# S.D. Ireland Companies \*Precast Division\*

Attention:	Ted Luck	Date:	6/4/2014
Company:	Luck Bros	Job Name:	Warren BRF 013-4(32)
Address:		Job Number:	SDI #14046
City, St, Zip:		Regarding:	Cold Joint request
Ph: / Fax:

**Notes/Remarks: Request to allow cold joint for casting of upper 5'-7-1/4" abutment wall**  
 Original submittal called out RX-101 water stop, which is not on the State approved products list. Therefore RX 101 has been eliminated and Greenstreak water stop used for entire far face back wall inclusive of proposed cold joint and field install infill joint around bridge beams as called out by engineer of record on return of original submittal.  
 Please note that waterstop 772 has been requested in lieu of waterstop 959, as 959 is currently not available. In addition waterstop 772 has a limited inventory due to Greenstreak extruder being under repair. Please expedite review to allow ordering of waterstop before inventory is depleted.

PRECAST CONCRETE ABUTMENT SHOP DRAWINGS (SDI JOB #14046)  
 SUPERVISOR: M. WHEELER  
 DETAILER: I. ADAMS  
 CHECKER: E. Barendse  
 ENGINEER: N/A

**Waterstops - PVC: Catalog Item: 959**

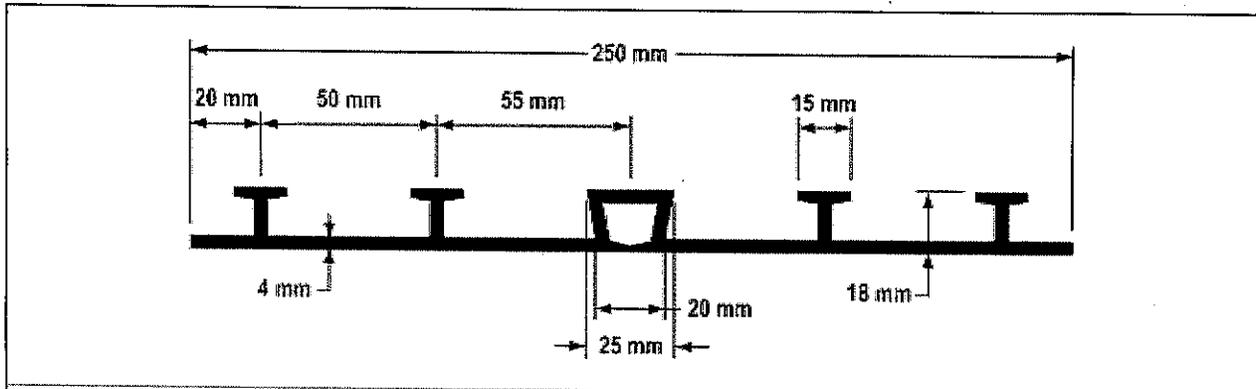
**Currently unavailable**

<input type="checkbox"/> Approved	<input checked="" type="checkbox"/> Approved As Noted
<input type="checkbox"/> Rejected	
<p><small>This review is only for general conformance with the design concept and the information given in the Construction Documents. Corrections or comments made on the shop drawings during the review do not relieve the Contractor from compliance with the requirements of the Plans and Specifications. Review of a specific item shall not include review of an assembly of which an item is a component. The Contractor is responsible for dimensions to be confirmed and corrected at the job site; information that pertains solely to the fabrication process or to the means, methods, techniques, sequences and procedures of construction; coordination of the Work with that of other trades and performing all Work in a safe and satisfactory manner.</small></p>	
Date: 6/6/2014	
By: D. Kull
